Economic Commission for Europe**Inland Transport Committee****World Forum for Harmonization of Vehicle Regulations****Working Party on Noise and Tyres****Seventy-seventh session**

UN Regulation No. 51 (Noise of M and N categories of vehicles)**Proposal for corrections to the 03 series of amendments to
UN Regulation No. 51****Submitted by the experts from the Informal Working Group on
Measurement Uncertainties, the Informal Working Group on
Additional Sound Emission Provisions and from the International
Organization for Standardization***

"Figure 4a

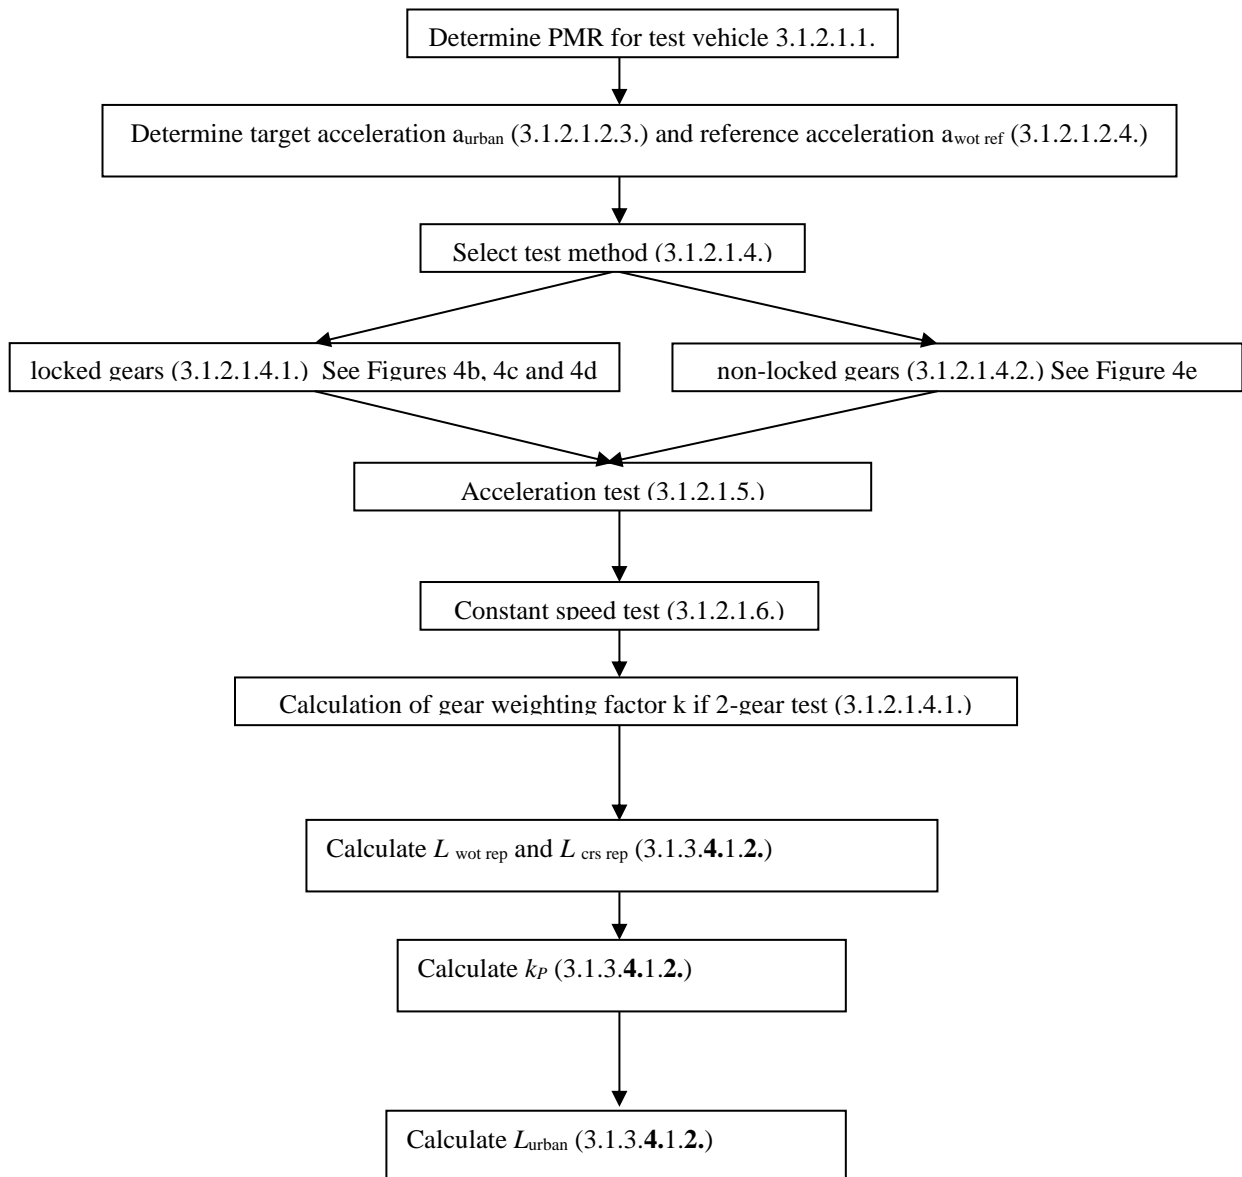
Figure 4a, amend to read:

3. The content of paragraph 3.1.3.1. was moved to paragraph 3.1.3.4.1.2. without any change when RD-ASEP was introduced in Supplement 7. In the figures, references to this paragraph 3.1.3.1. need to be renumbered to 3.1.3.4.1.2., accordingly.

"Figure 4b

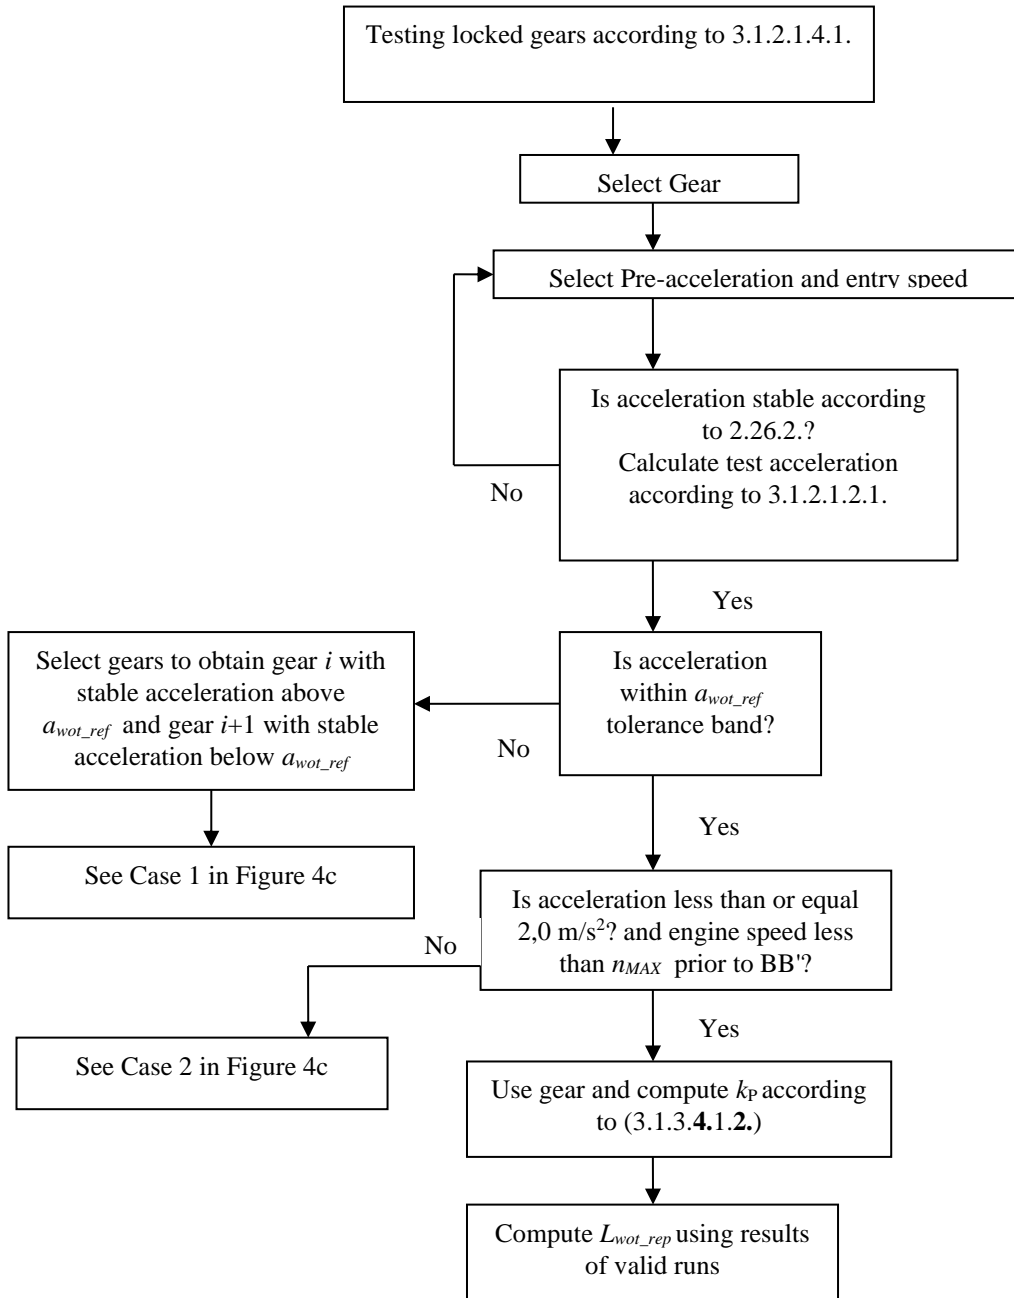
Figure 4b, amend to read:

"Figure 4c

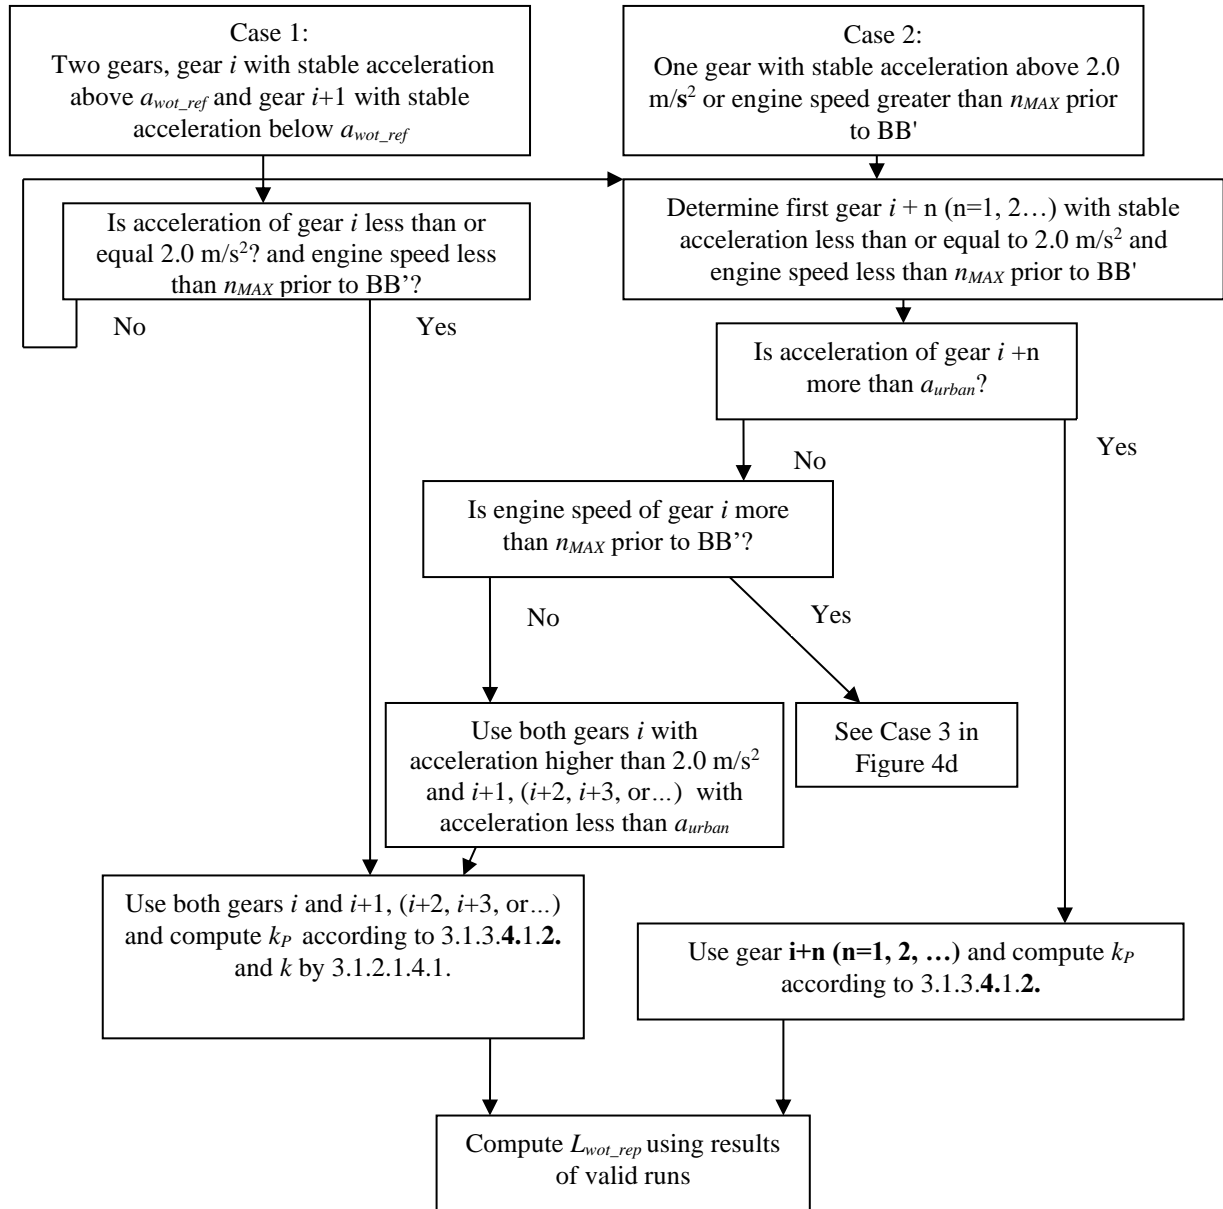
Figure 4c, amend to read:

4. In Figure 4c, from the current wording in Annex 3, paragraph 3.1.2.1.4.1.(c), the addition of "i+n (n=1, 2, ...)" in the box "Use gear and compute k_p according to 3.1.3.4.1.2." was made for better understanding and clarification.

"Figure 4d

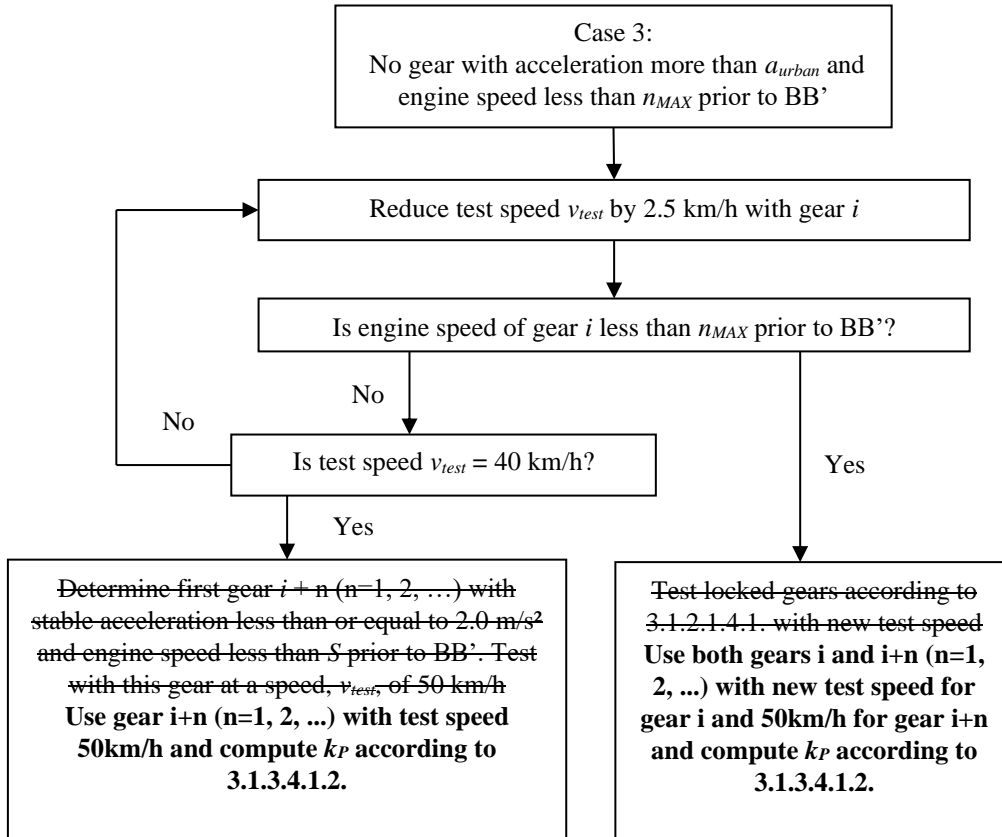
Figure 4d, amend to read:

5. In Figure 4d, to avoid misinterpretation, the following modifications were made from the current wording in Annex 3, paragraph 3.1.2.1.4.1.(d) for clarification and better understanding:

- Adding "=" in the box "Is test speed v_{test} 40km/h".
- Replacing "Determine first gear $i + n$ ($n=1, 2, \dots$) with stable acceleration less than or equal to 2.0 m/s^2 and engine speed less than S prior to BB' . Test with this gear at a speed, v_{test} , of 50 km/h" by "Use gear $i+n$ ($n=1, 2, \dots$) with test speed 50km/h and compute k_p according to 3.1.3.4.1.2".
- Replacing "Test locked gears according to 3.1.2.1.4.1. with new test speed" by "Use both gears i and $i+n$ ($n=1, 2, \dots$) with new test speed for gear i and 50km/h for gear $i+n$ and compute k_p according to 3.1.3.4.1.2."

"Figure 4e

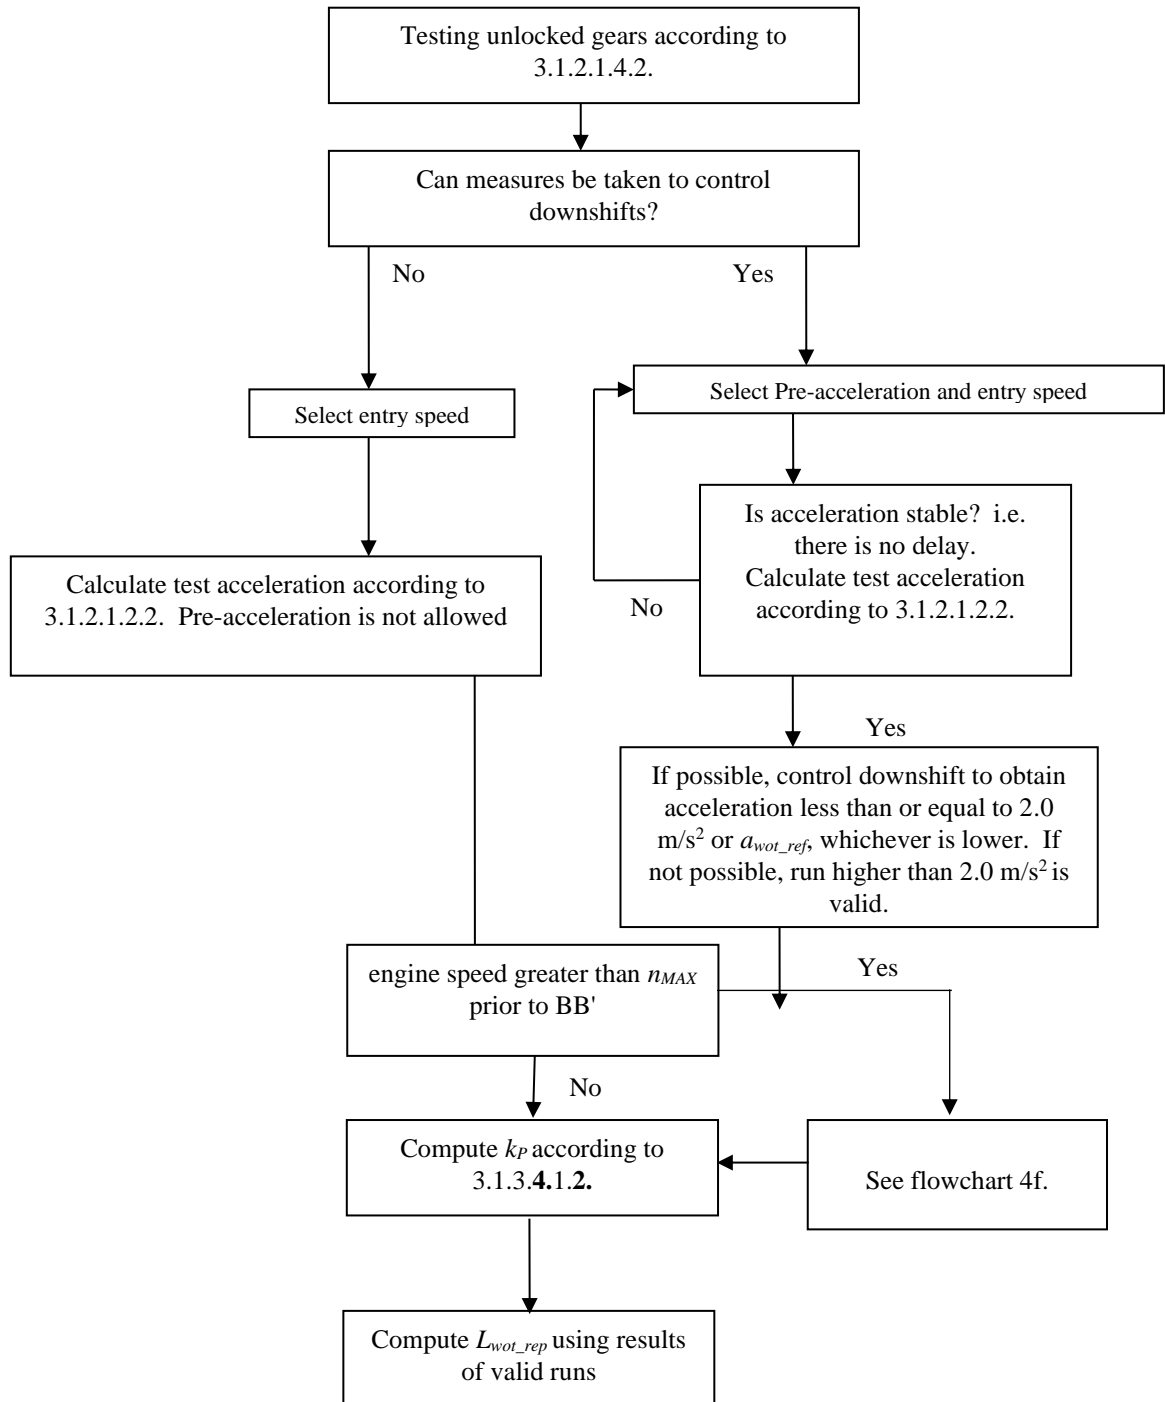
Figure 4e, amend to read:

“Figure 4f

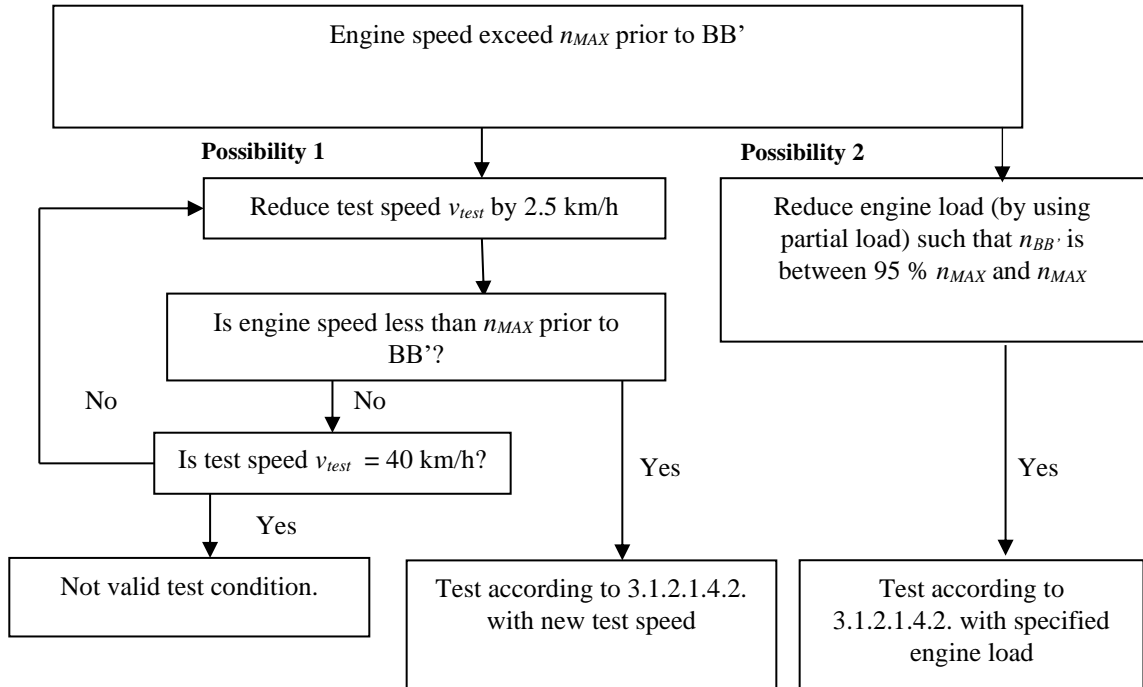
Figure 4f, amend to read:

6. In Figure 4f, from the current wording in Annex 3, paragraph 3.1.2.1.4.2., the addition of “=” in the box “Is test speed v_{test} 40km/h” was made for better understanding and clarification.
